**ALICE C. HARRIS INTERMEDIATE SCHOOL COOLING UPGRADE**  
515 NORTH HUSKY WAY (800 WEST), TREMONTON, UTAH 84337

**AREA 6 - ELECTRICAL PLAN**

**EP1.6**

**1 AREA 6 - ELECTRICAL POWER PLAN**  
EP1.6 SCALE: 1/8"=1'-0"

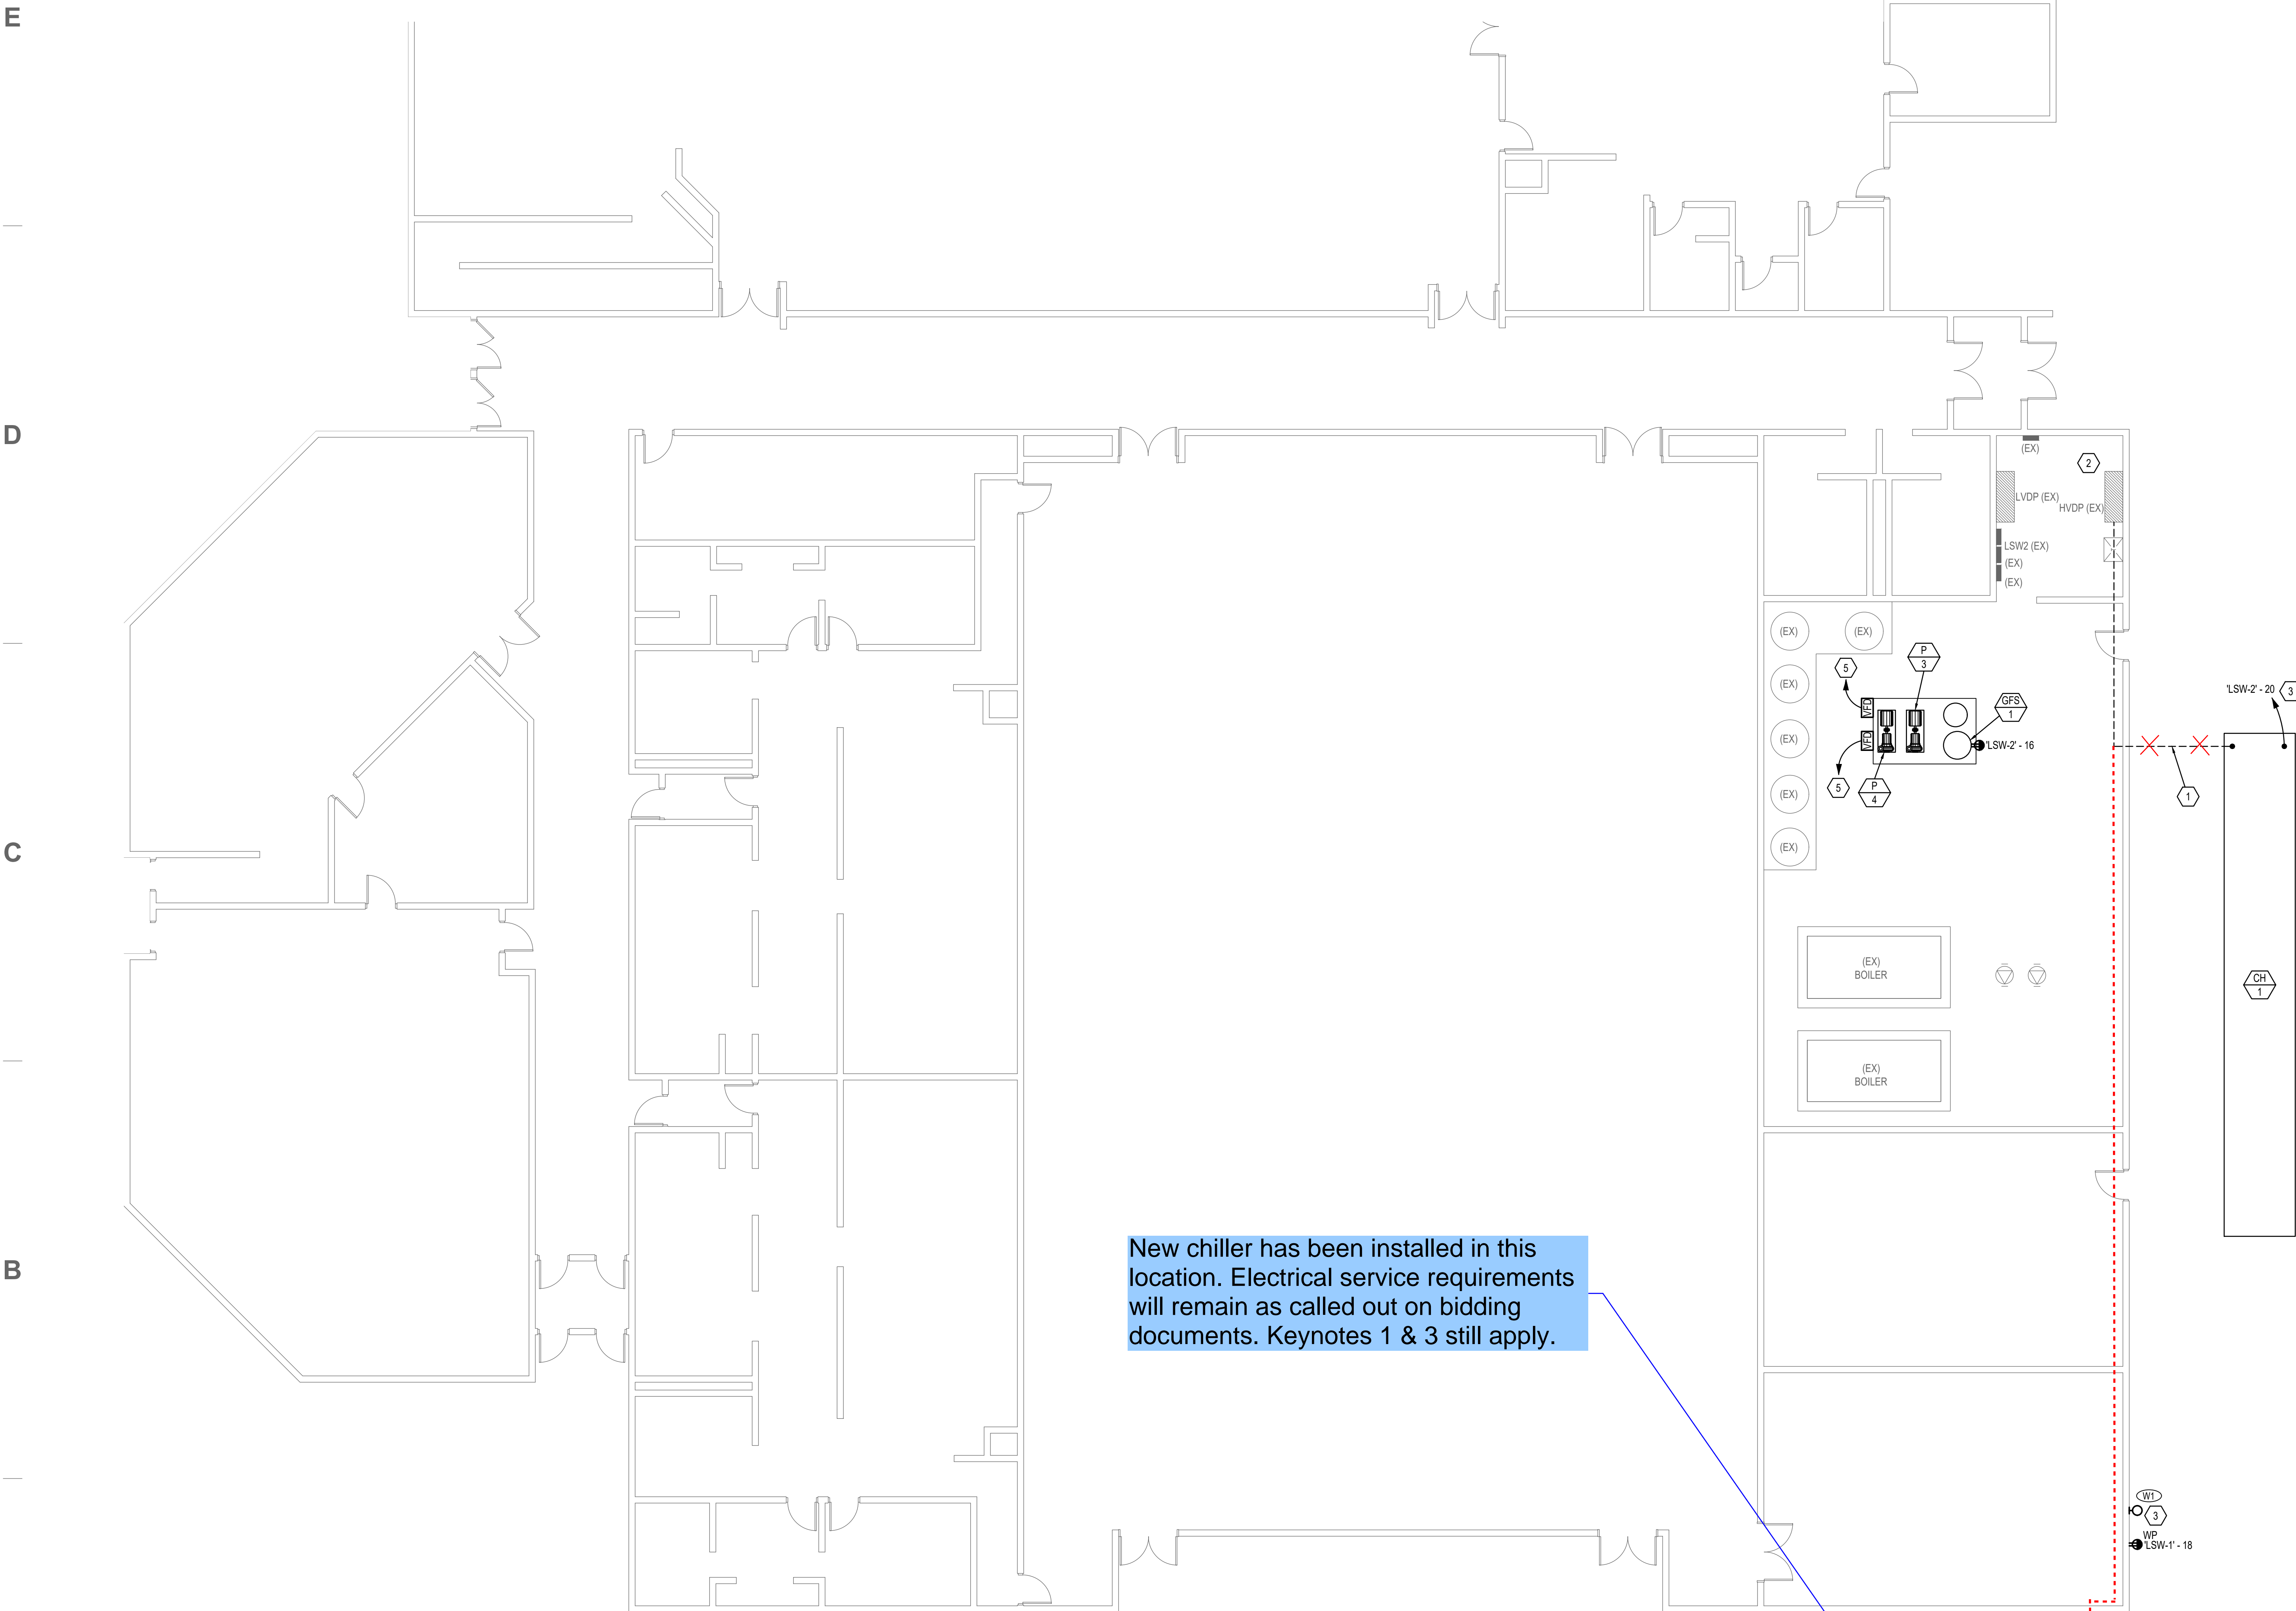
New chiller has been installed in this location. Electrical service requirements will remain as called out on bidding documents. Keynotes 1 & 3 still apply.
